# WATER QUALITY MEMORANDUM

Utah Coal Regulatory Program

RE: 2008 First Quarter Water Monitoring, Genwal Resources, Inc., Crandall Canyon Mine, WQ08-1, Task ID #3138

## Total Dissolved Solids (TDS)

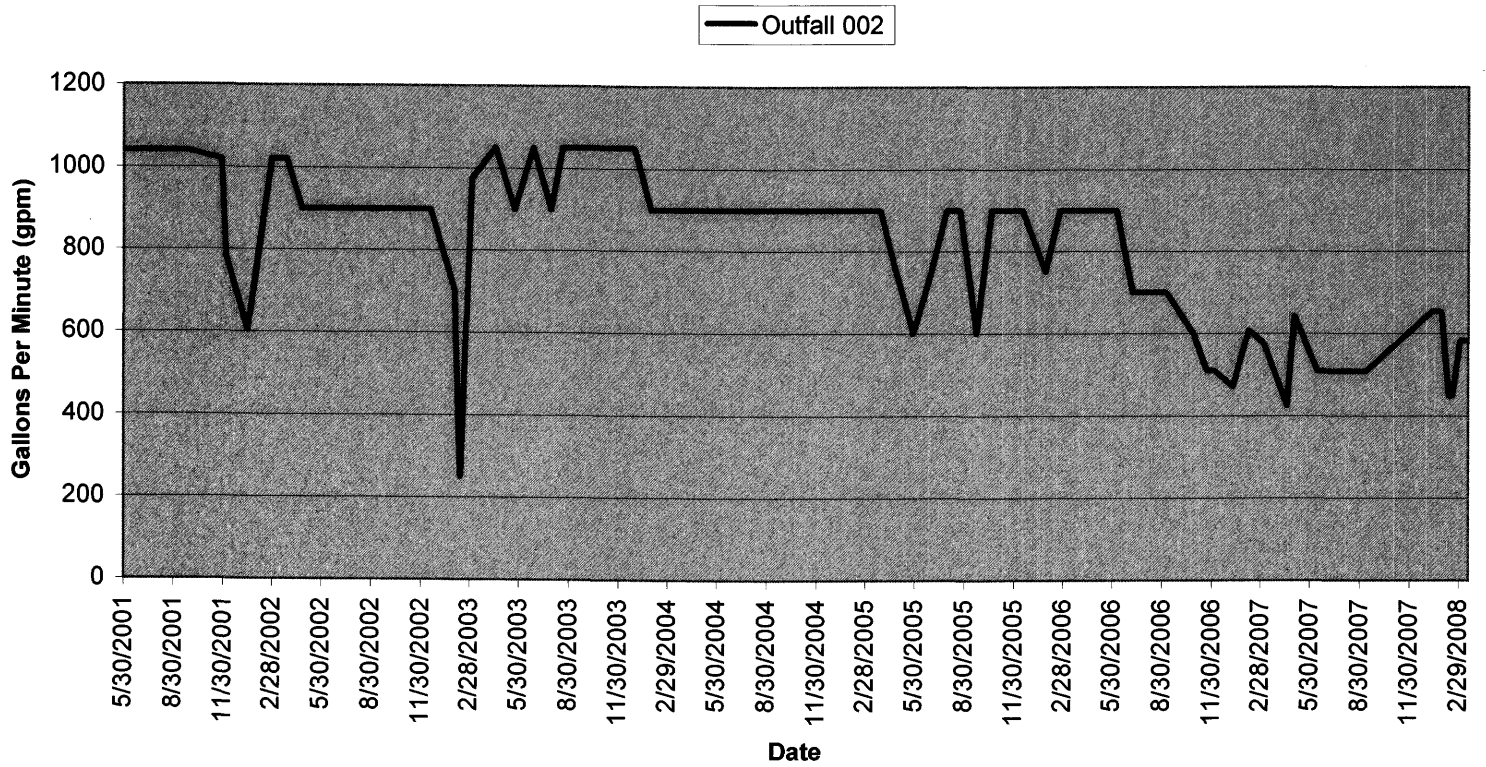
The compliance level for TDS (as established by the UPDES discharge permit) is 1,200 ppm. The sampling events of January 10<sup>th</sup> and January 28<sup>th</sup> produced analytical results of 1,523 ppm and 1,108 ppm respectively.

At this point, it's unclear as to what's causing the spikes in TDS and T-Fe. Re-entering the mine is not an option. Additionally, the TDS and T-Fe data collected during this quarter is insufficient to determine what (if any) trend is being produced as a result of the mine-water discharge. Additional monitoring/data collection is necessary.

Continued data collection and monitoring of the mine-water discharge will be necessary to determine if a trend is emerging relative to TDS and T-Fe. The data will be essential in determining whether the mine-water discharge remains in compliance with the UPDES permit.
